MIL-B-49450/5(ER)
AMENDMENT 2
19 July 1988
SUPERSEDING
AMENDMENT 1
18 June 1987

BATTERY, RECHARGEABLE, NICKEL-CADMIUM, VENTED, AIRCRAFT

BB-716/A, HARNESS ASSEMBLY

FIGURE 4. M49450/5-3 THERMISTOR ASSEMBLY (METHOD 1).

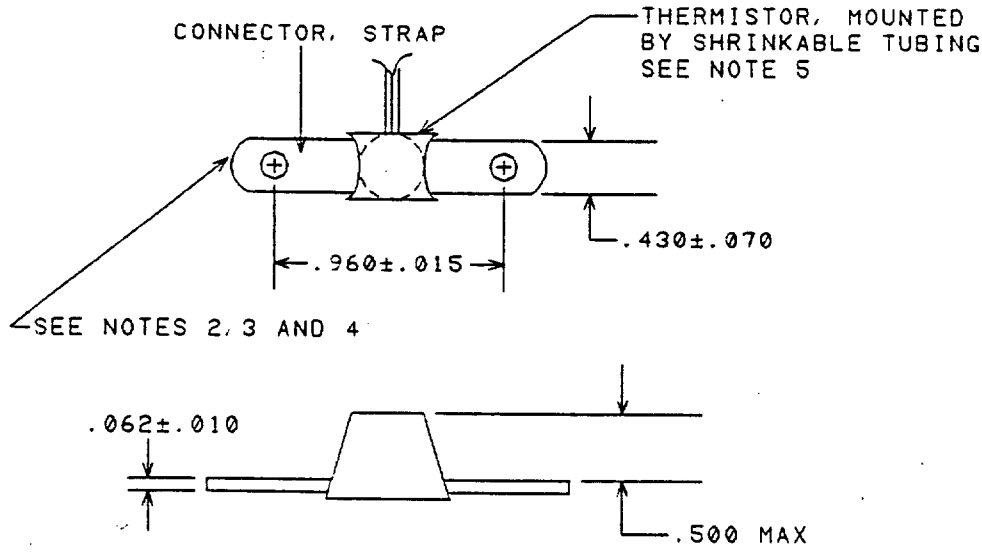
* Figure 4, delete in its entirety and substitute:
